24/00560/HYB – LAND SOUTH OF STATION ROAD, MARKET BOSWORTH

ADC Infrastructure Limited are commissioned by the applicant, Miller Homes, to provide transport and highways advice in support of a hybrid planning application for the construction of 138 residential dwellings and 0.55ha of employment use on land to the south of Station Road in Market Bosworth. The planning application was supported by a Transport Assessment and Travel Plans.

This letter has therefore been produced to present the updated vehicle tracking assessment and traffic calming features proposed to ensure suitable design speeds throughout the development.

Project Reference	Type	Number	Revision
ADC3326-DR- 005			P6

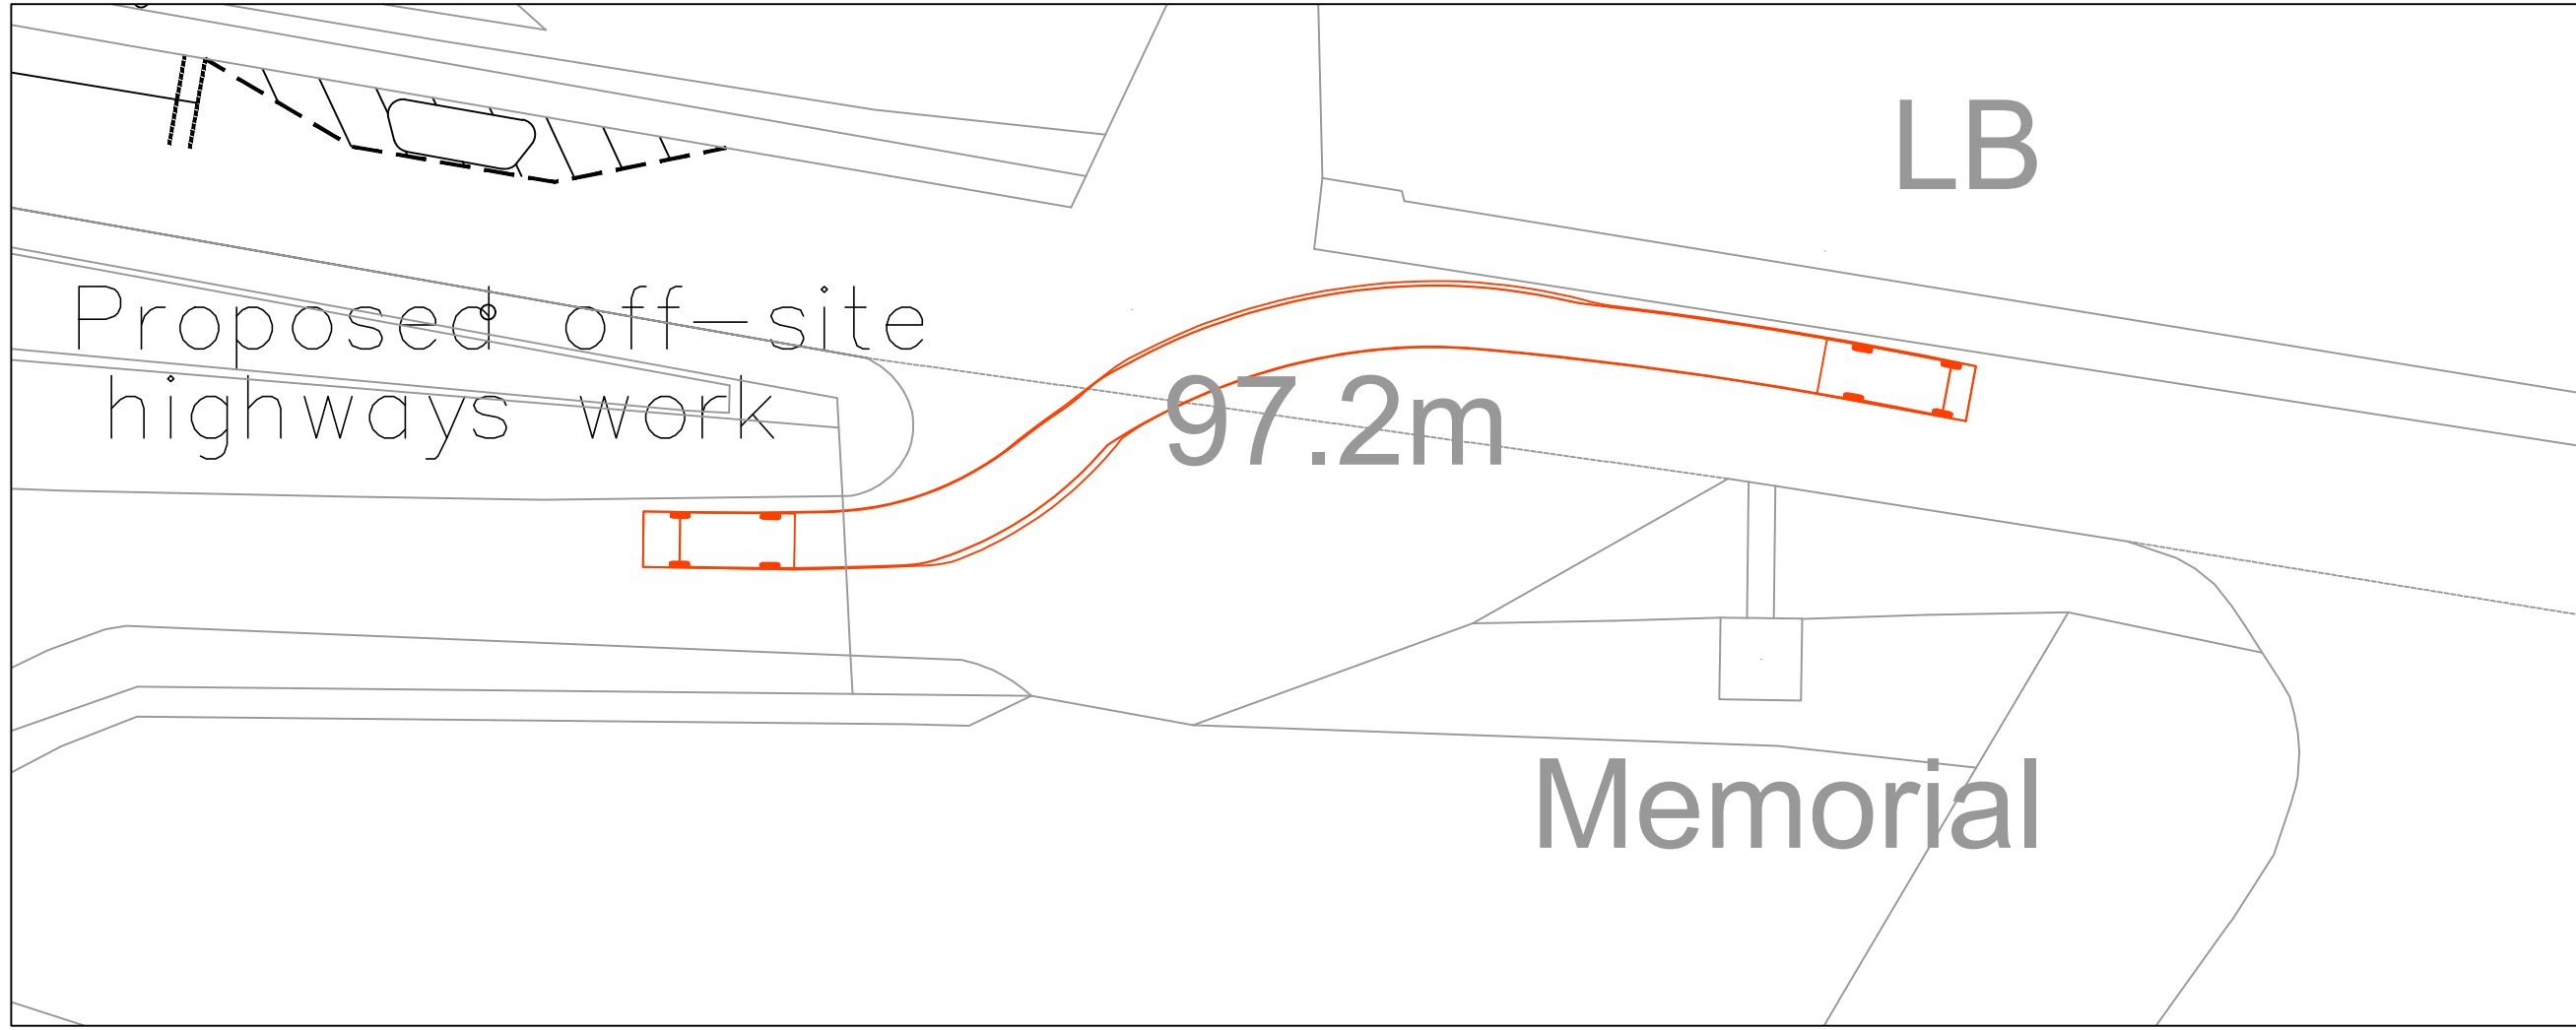
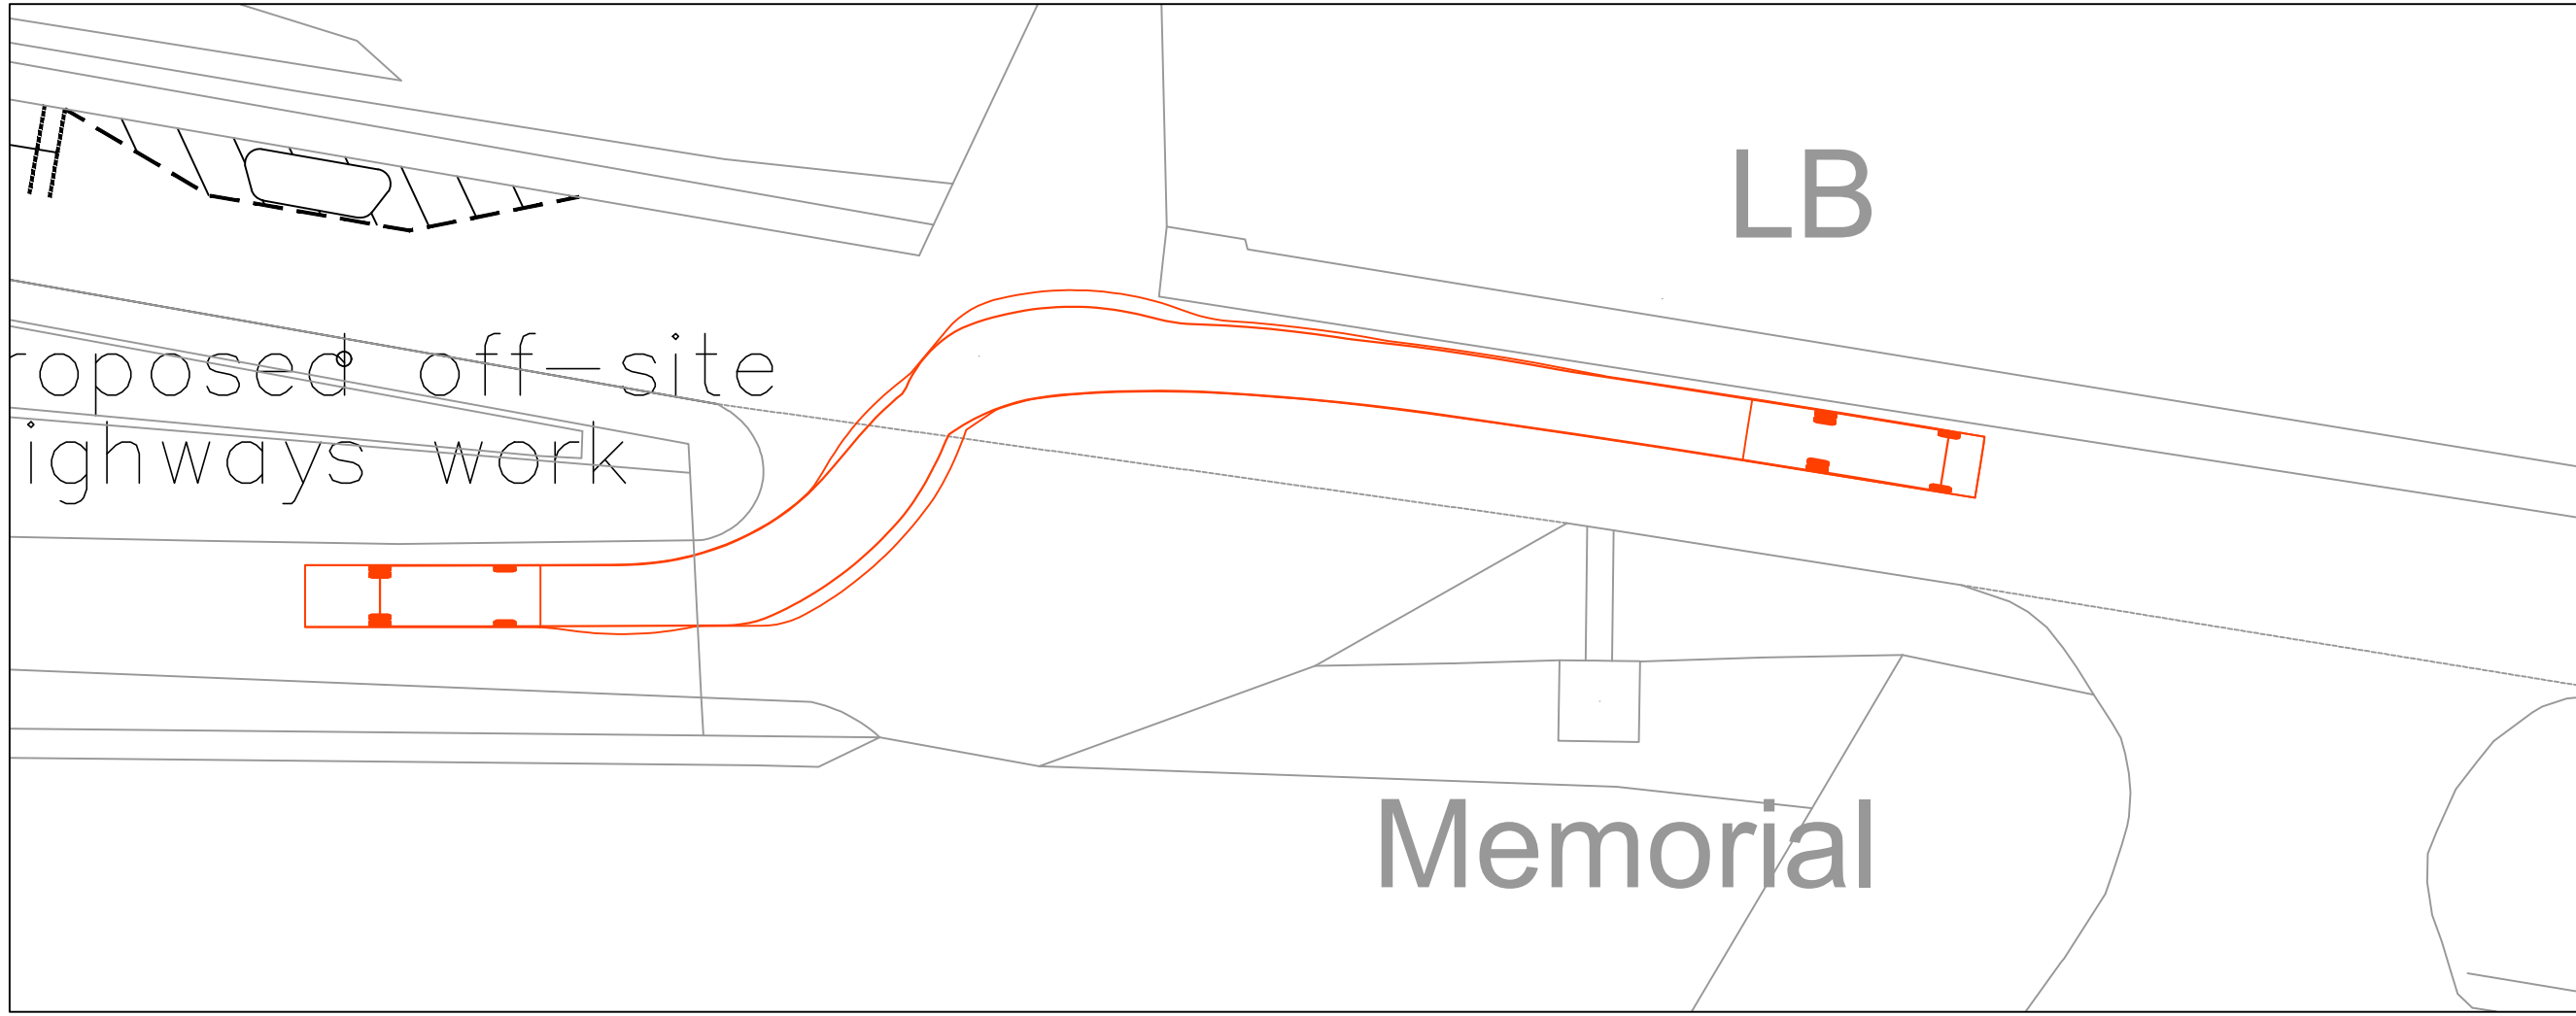
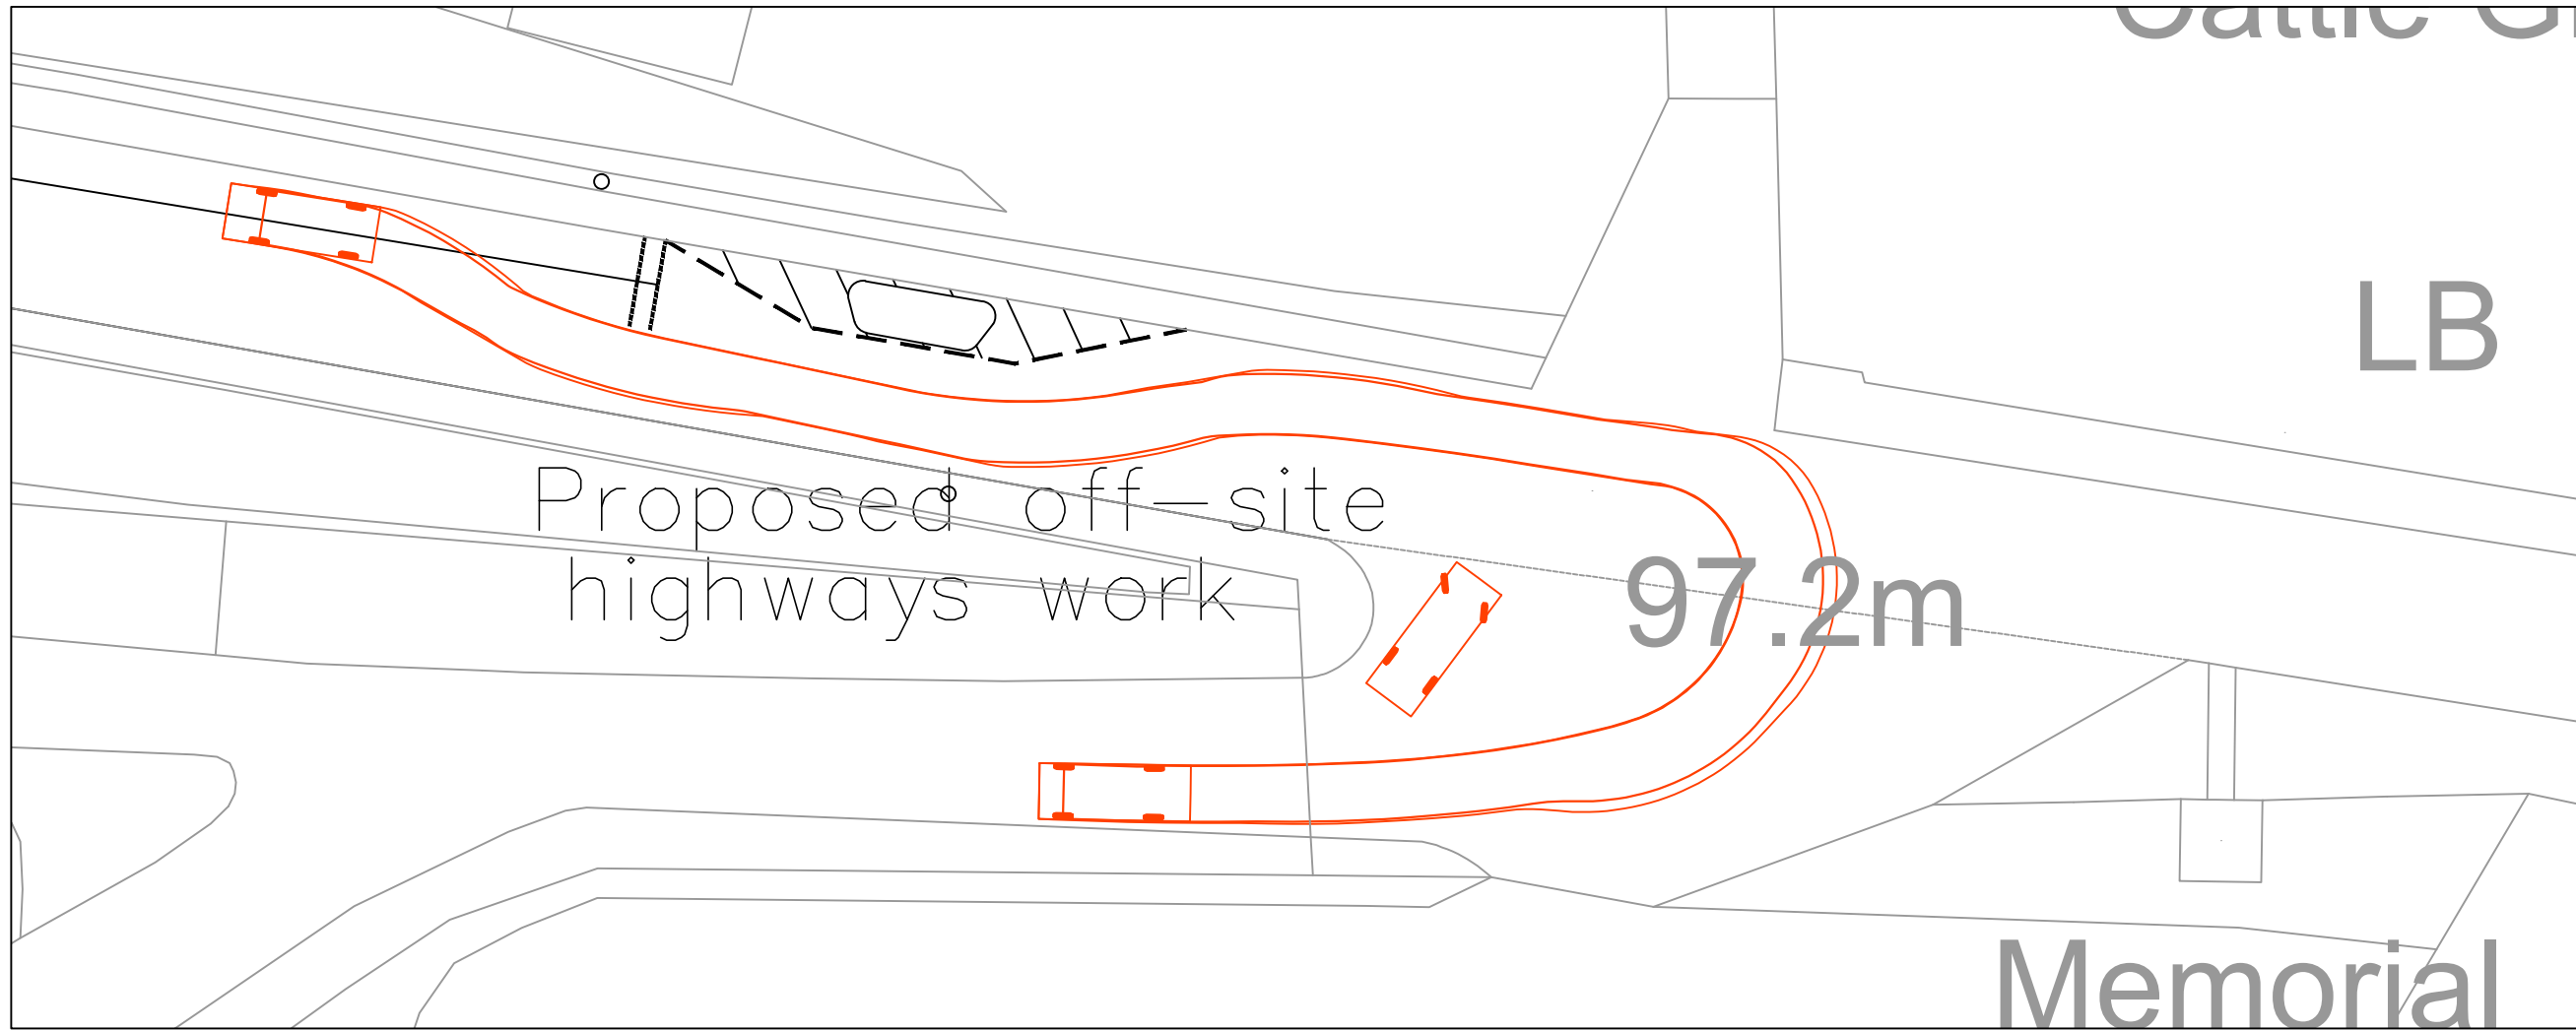
- Turning for a refuse vehicle has been shown, however the specification including the dimensions of the vehicle should be clarified and in line with the Swept Path Analysis guidance within the LHDG. This could be shorter than the 11.2m stated within the LHDG.

- The visibility splay looks to go over a tiny bit of third party land
- Changes will be needed to the swept path for refuse vehicles – it looked like the wrong size of vehicle had been used. This might affect the road layout and plot positions
- Traffic calming needed improving
- There remains an issue with the railway station access

Vehicle tracking of an 11.2m refuse vehicle has been undertaken. The vehicle tracking assessment is shown in **Drawing ADC3326-DR-005-P6** and demonstrates that the design vehicle can access, turn using the turning heads provided and exit again onto Station Road in a forward gear.

The drawing also demonstrates that the refuse vehicle can travel in both directions on the bends in the eastern parts of the development whilst opposed by a large car. As a result, the development layout is suitable to serve refuse and servicing vehicles.
